SUBJECT: AMENDMENT TO BYRON FUEL STORAGE LICENSE
(BOARD NOTIFICATION 84-168)

Subject: Byron Generating Station Units 1 and 2
 Special Nuclear Materials License
 Number SNM-1917
 NRC Docket Nos. 50-454 and 50-455

PROPOSED CHANGED TO SNM-1917

DOCKET NO.: 70-2973
LICENSE NO.: SNM-1917
LICENSEE: Commonwealth Edison
FACILITY: Byron Unit 1
SUBJECT: SAFETY EVALUATION REPORT - REVIEW LICENSE AMENDMENT
APPLICATION DATED SEPTEMBER 13, 1984

FIGURE 9.1-2

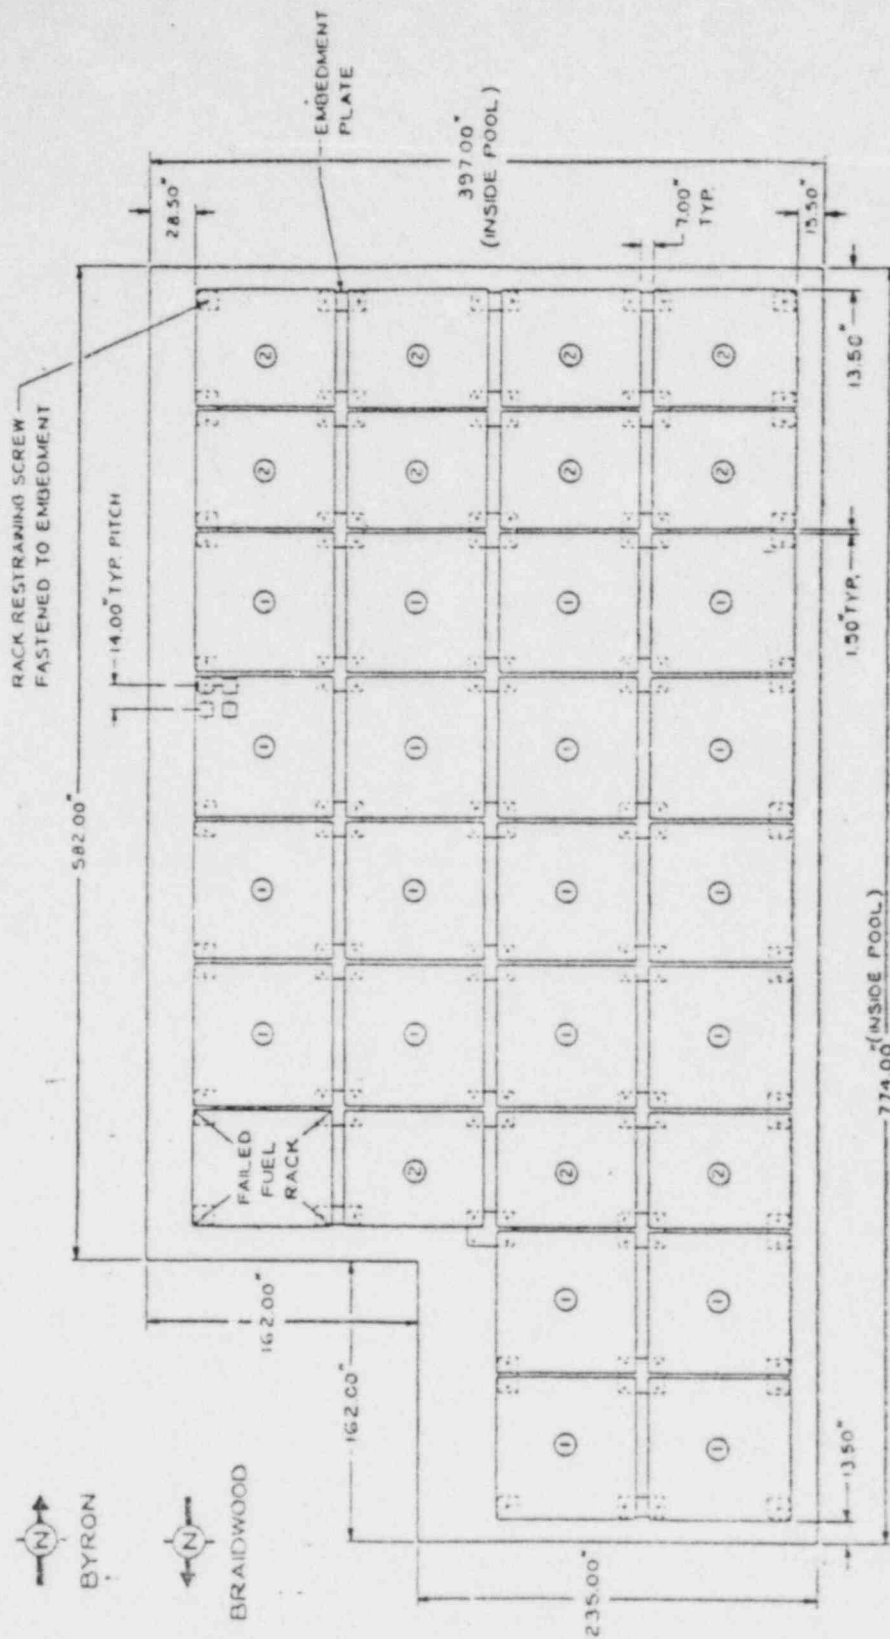
- 18.b The fuel assemblies shall be stored in a checkerboard pattern in the Spent Fuel Racks. Two fuel assemblies may be placed in two damaged fuel storage containers for Primary Neutron Source installation and shielded storage provided the center-to-center spacing of these assemblies and all other adjacent fuel assemblies exceeds 20 inches.
- 20 Fuel assemblies shall be stored in such a manner that water would drain freely from the assemblies in the event of flooding and subsequent draining of the fuel storage area. However, two fuel assemblies may be placed in two water filled damaged fuel storage containers for Primary Neutron Source installation and shielded storage provided that the water used is at greater than 2000 ppm boron concentration.

Due to ALARA considerations it is desirable to install the two californium primary neutron sources into two new fuel assemblies in the spent fuel pit. Two damaged fuel storage containers filled with borated water will be used for radiation shielding. The containers will be located in the failed fuel container rack shown in FSAR figures 9.1-2 and 9.1-4 (enclosed). This rack is designed to maintain the center-to-center spacing at greater than 20 inches. The installation operation will be performed shortly before the start of core loading and the two new fuel assemblies with installed neutron sources will be temporarily stored in these containers until transferred to the reactor.

The two fuel assemblies to receive primary sources will be installed in failed fuel containers located in two nonadjacent failed fuel container rack locations 44 inches apart. The failed fuel container has the cylindrical dimension of a 13 inch schedule 10 pipe and contains a stainless steel angle framework centered in the container to support the fuel assembly. This framework is nominally 9 inches square. Between the two loaded failed fuel containers will be a third, borated water filled failed fuel container to be used as a shielded temporary storage location for the primary source rod. When we unload the new fuel vault into the spent fuel pit, the closest a new fuel assembly would be stored with respect to a source bearing assembly would be $20 \frac{3}{8}$ inches.

Twenty inches is greater than the minimum checkerboard center-to-center spacing. This arrangement has been analyzed by NUS Corporation the original rack criticality analyst, and found to have no adverse affect on the original results.

Condition 18.b. The fuel assemblies in the Spent Fuel Storage Racks shall be stored in a checkerboard pattern. However, one fuel assembly may be placed in each of two storage locations of the Failed Fuel Container Rack provided they are no closer than 20 inches (center-to-center) from the nearest fuel assembly in the Spent Fuel Storage Racks and no closer than 44 inches (center-to-center) from each other.

FIGURE 9.1-4

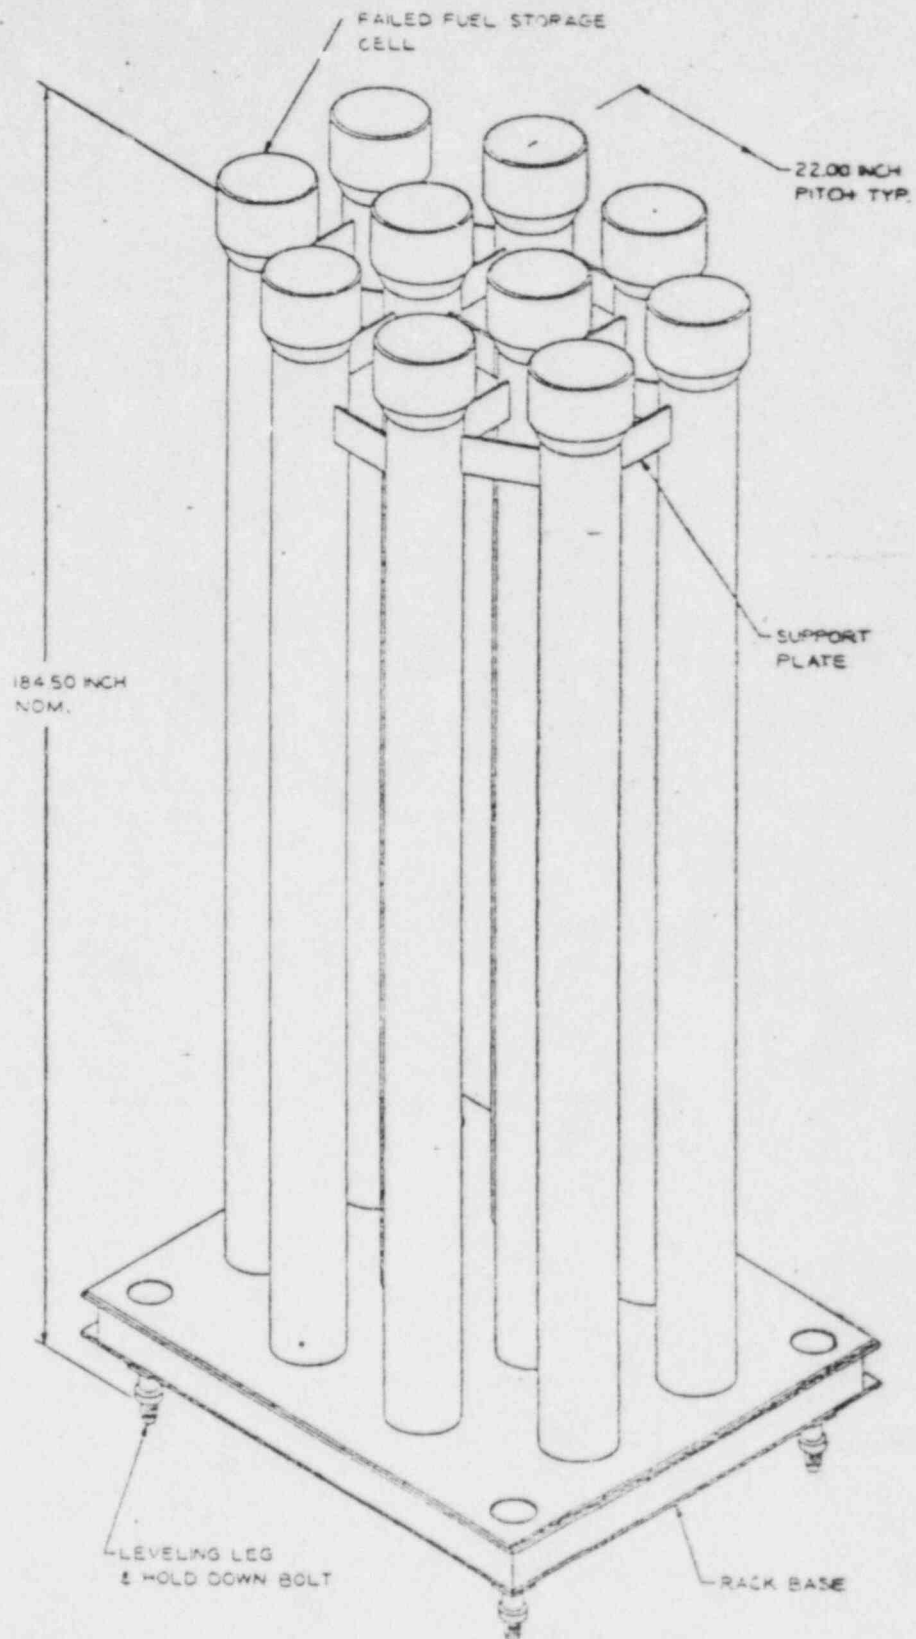
The total amount of water used will not exceed 250 gallons. Even if this borated water were to completely leak into the surrounding Spent Fuel Pit, it would be less than 1/4 inch in depth, still more than 18 inches below the active fuel in storage.

The Failed Fuel Container Rack is located in the Spent Fuel Pool at the southwest corner of the array of the spent fuel racks. It provides storage for 10 failed fuel assemblies spaced on 22-inch centers. CE requests the storage of only two fuel assemblies in this rack spaced on 44-inch centers (the steel pipe in the in-between position to be filled with borated water to be used as a neutron shielded temporary storage location for the startup source rod prior to assembly into one of the two fuel assemblies). The shortest distance between two adjacent assemblies in

the Spent Fuel Storage Pool Racks is 19.8 inches center-to-center. Since the spacing between the two fuel assemblies in the Failed Fuel Container Rack is greater than those between assemblies in the New Fuel Vault and the Spent Fuel Storage Pool Racks, the combined arrays are safe independent of the degree of water moderation within and between assemblies. Therefore, it is recommended Condition 18.b be modified as follows:

The two fuel assemblies in the Failed Fuel Container Rack are to be submerged in water. Since it has been shown that two assemblies separated from each other by 12 inches cannot be made critical independent of the degree of water moderation within and between assemblies, they cannot be made critical whether the assemblies are submerged or not. Since Condition 20 does not allow the storage of fuel assemblies unless water would drain freely from the assemblies in the event of flooding and subsequent draining (e.g., no water between assemblies but water within assemblies), it is recommended Condition 20 be modified to allow the two assemblies to be submerged in water.

Condition 20. Fuel assemblies shall be stored in such a manner that water would drain freely from the assemblies in the event of flooding and subsequent draining of the fuel storage area. However, one fuel assembly may be placed in each of two water-filled fuel assembly storage locations (44 inches center-to-center) in the Failed Fuel Container Rack.
